GEC INDEX SHEET

UNTIL SUCH TIME AS THESE DRAWINGS ARE APPROVED BY THE APPROPRIATE REVIEWING AGENCIES, JR ENGINEERING APPROVES THEIR USE DESIGNATED BY WRITTEN AUTHORIZATION.	PREPARED FOR	SR LAND, LLC 20 BOULDER CRESCENT 2ND FLOOR COLORADO SPRINGS, CO 80903 JAMES F. MORLEY (719) 419-3024
	DESIGNED BY	JR ENGINEERING A Westman Company Central 303-740-9888 • Colorado Springs 719-583-2583 Fort Collins 970-491-9888 • www.jrengineering.com
BY	DATE	
No.	REVISION	
H-SCALE	1"=400'	N/A
V-SCALE		
DATE	7/18/23	DJV
DESIGNED BY		WLL
DRAWN BY		
CHECKED BY		
SAND CREEK RESTORATION	GEC PLANS	
SHEET 96	OF 121	
JOB NO.	25188.04

SAND CREEK RESTORATION	GEC INITIAL	BY	DATE	No.	REVISION
		H-SCALE	1"=60'		
		V-SCALE	N/A		
		DATE	7/18/23		
		DESIGNED BY	DJV		
		DRAWN BY	WLL		
		CHECKED BY			
		SHEET	97	OF	121
		JOB NO.	25188.04

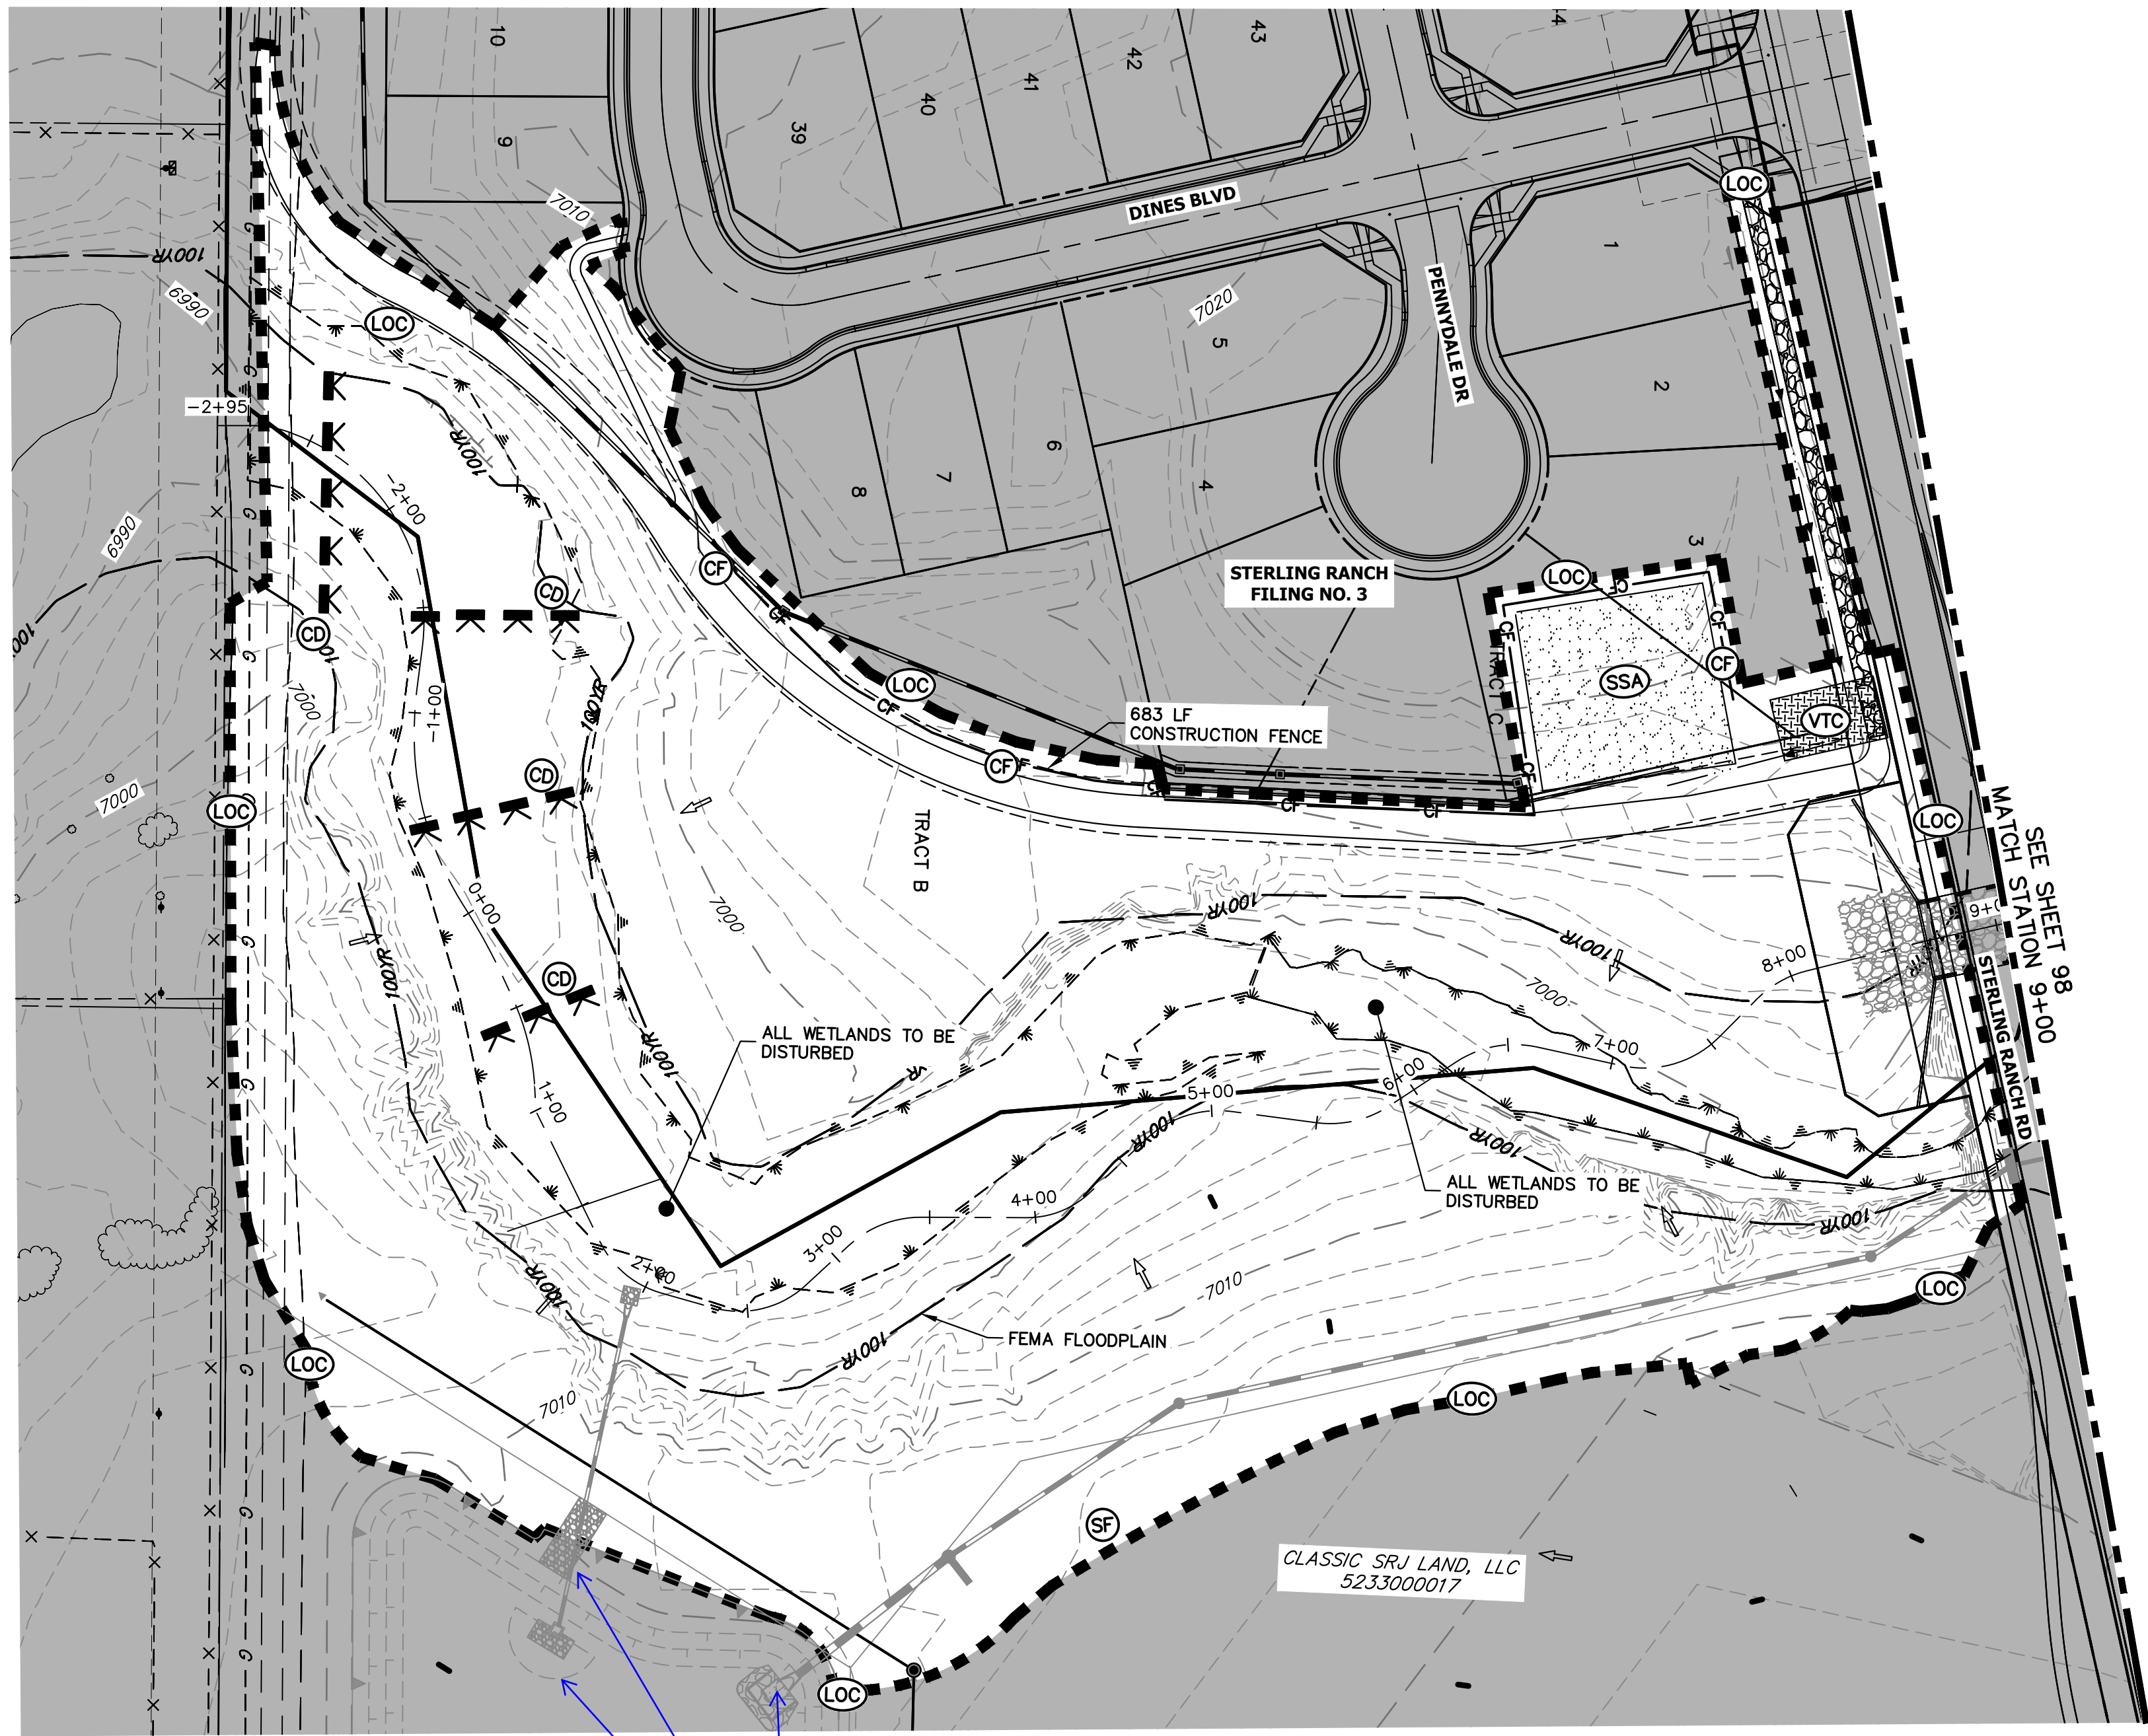
Unresolved: Label facilities

SAND CREEK RESTORATION	GEC INITIAL
SHEET 99 OF 121	JOB NO. 25188.04

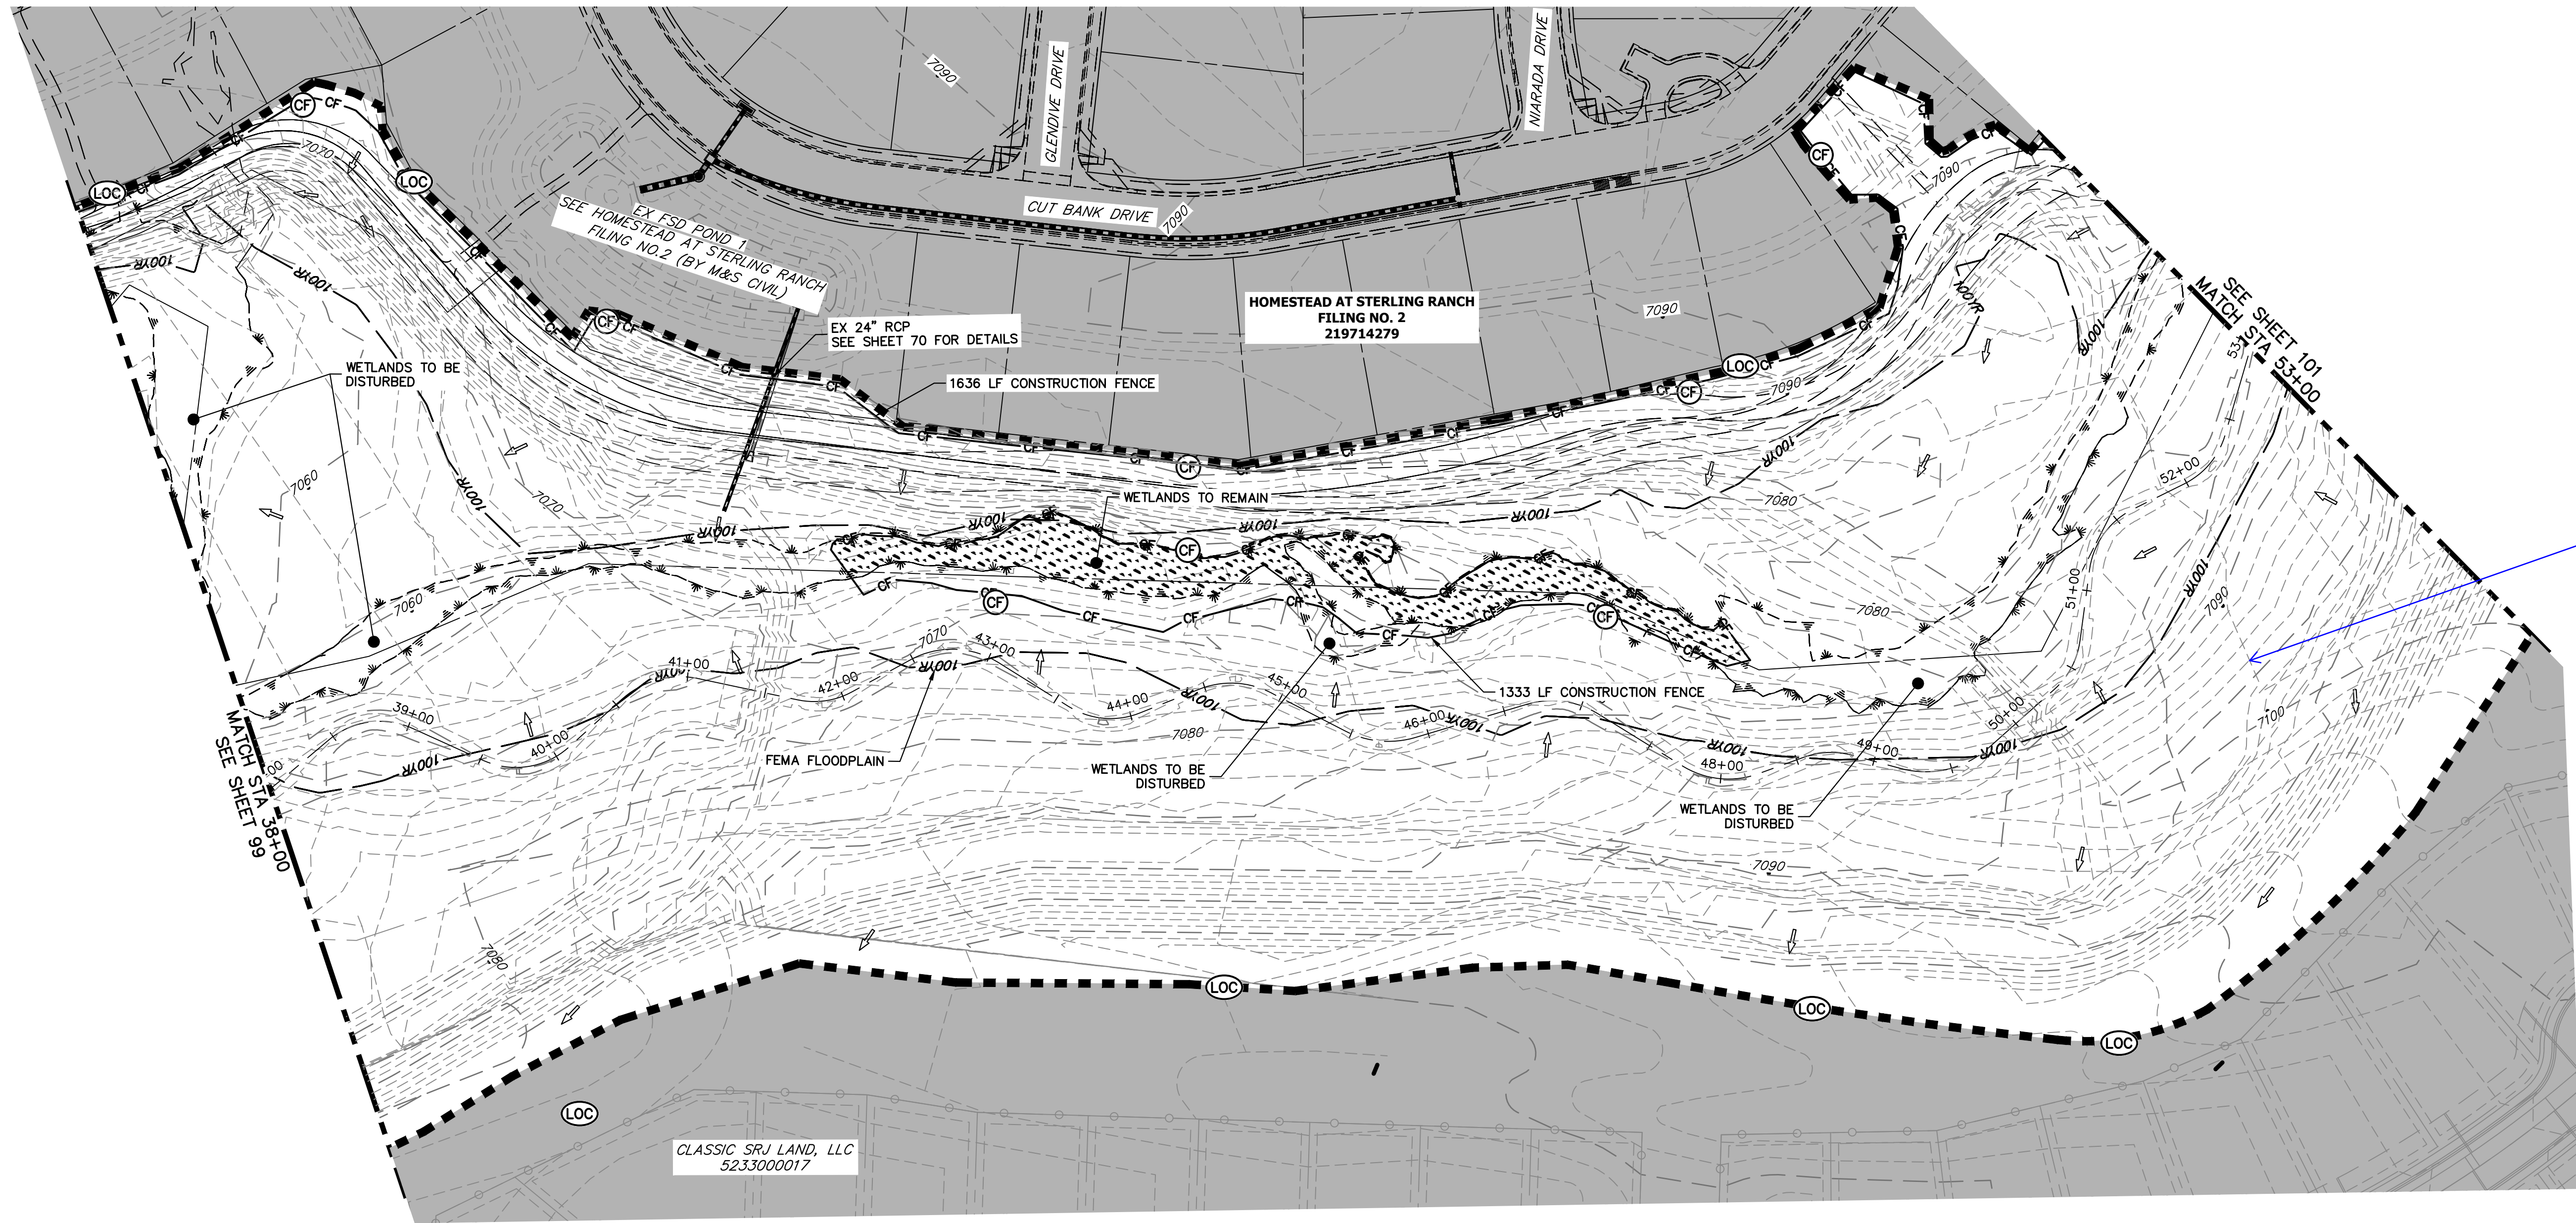
Too many contours

SAND CREEK RESTORATION	GEC INITIAL	SHEET 103 OF 121
		JOB NO. 25188.04

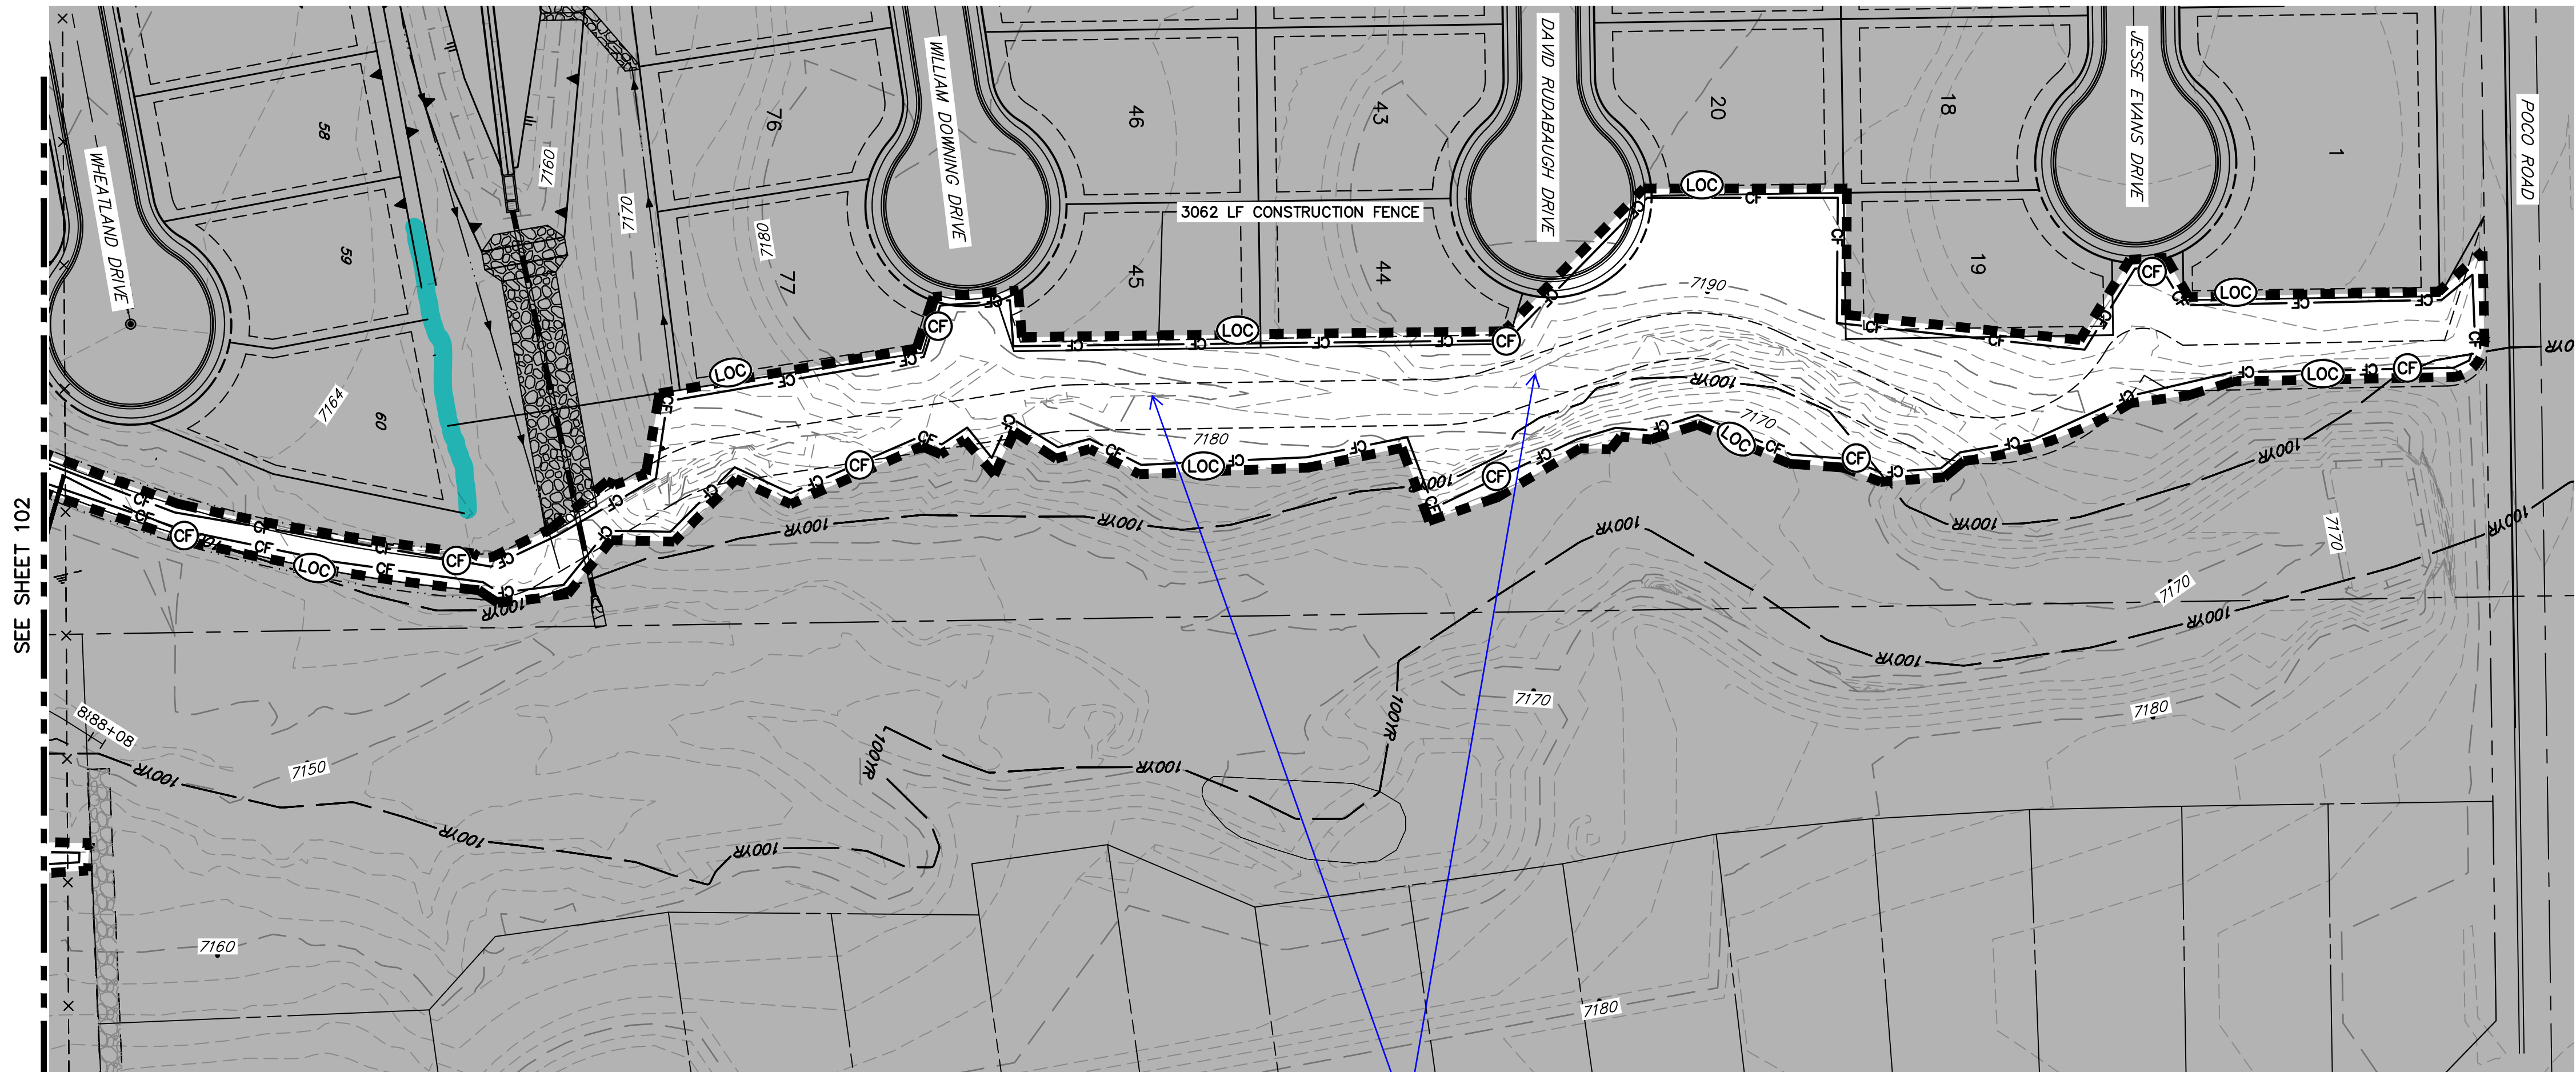
Check contours
